# Product Change Notification

Change Notification #: 832784-00

Change Title: 2100W AC Common Redundant Power Supply FCXX2100CRPS, Manufacturing Site Change and Label Update

Date of Publication: September 10, 2024

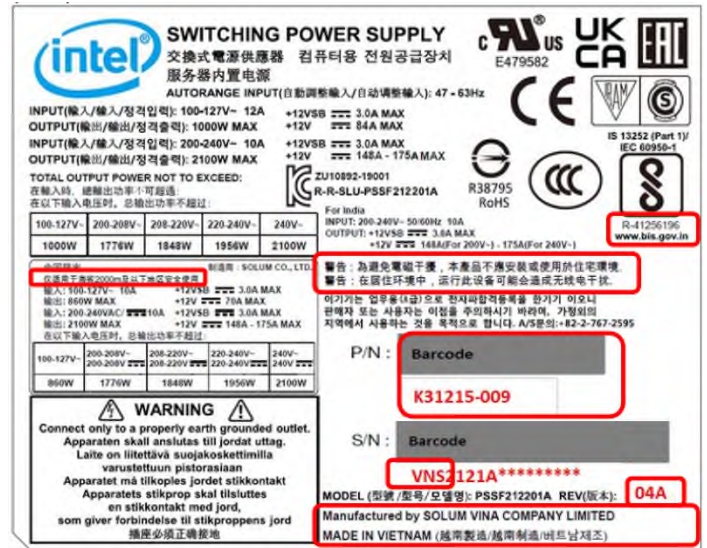
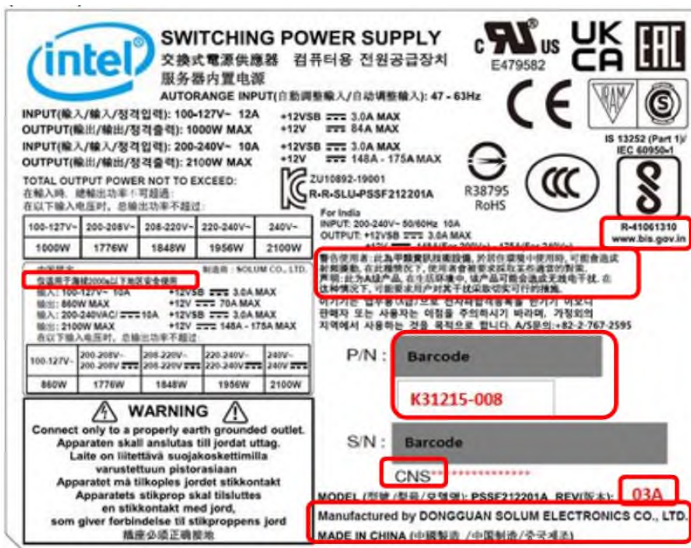
- Because this power supply's manufacturing moved from China to Vietnam, the labels on the power supply unit and on the packaging will be changed to reflect this transition. Please see examples of the labels below.
- The Intel Product Code will be changed as well.
